Access Compliance Report

Public Rights-of-Way

Intersection ID: 53351	Main Street: MARVIN_RD	Cross Street: SAPPHIRE_HILL_LN	Location: SE
ADA ID: D9B5D07E526E	Ramp Type: BlendTrans1	Initial Pass/Fail: Fail	Overall Compliance: No
		Severity Score: 25

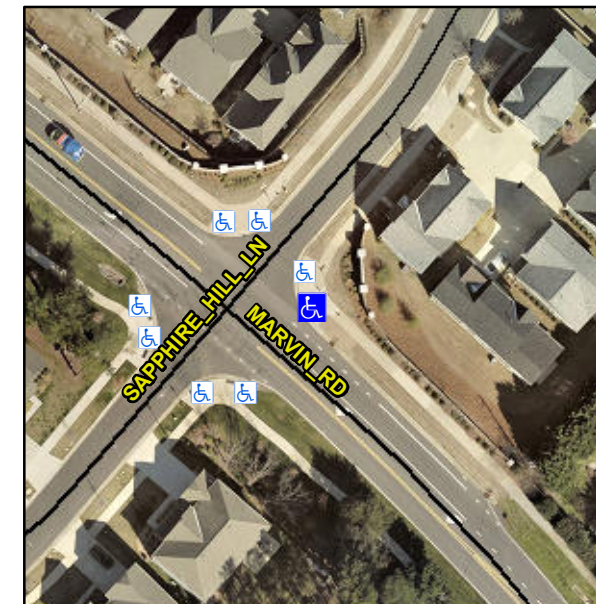
R304.5.3

Compliance	Description	Data	Compliance	Description	Data
N/A	Ramp Length (in)	93.5	Yes	BlendTrans Slope (%)	3.2
Yes	Ramp Width (in)	60.0	No	BlendTrans XSlope (%)	10.2
N/A	Flare Type LT	N/A	N/A	Flare Type RT	N/A
N/A	Flare Slope LT (%)	N/A	N/A	Flare Slope RT (%)	N/A
N/A	Flare Traversable LT?	N/A	N/A	Flare Traversable RT?	N/A
N/A	Landing Length (in)	N/A	N/A	DWS Provided?	N/A
N/A	Landing Width (in)	N/A	N/A	DWS Contrast?	N/A
N/A	Landing Slope (%)	N/A	N/A	DWS Length (in)	N/A
N/A	Landing X Slope (%)	N/A	N/A	DWS Full Width?	N/A
N/A	Landing Curb? (Y/N)	N/A	N/A	DWS Offset (in)	N/A
N/A	Shared Landing?	N/A			
N/A	Gutter Ponding?	N/A	N/A	Gutter Slope (%)	N/A
N/A	Gutter Lip Ht (in)	N/A	N/A	Gutter X Slope (%)	N/A
N/A	Painted X Walk1?	No	N/A	Painted X Walk2?	N/A
	X Walk 1 Direction	To SW		X Walk 2 Direction	N/A
	X Walk 1 Width (in)	N/A		X Walk 2 Width (in)	N/A
	X Walk 1 Slope (%)	5.4		X Walk 2 Slope (%)	N/A
	X Walk 1 X Slope (%)	1.7		X Walk 2 X Slope (%)	N/A

Remove & Replace Curb Ramp With Two New Directional Ramps or Equivalent.
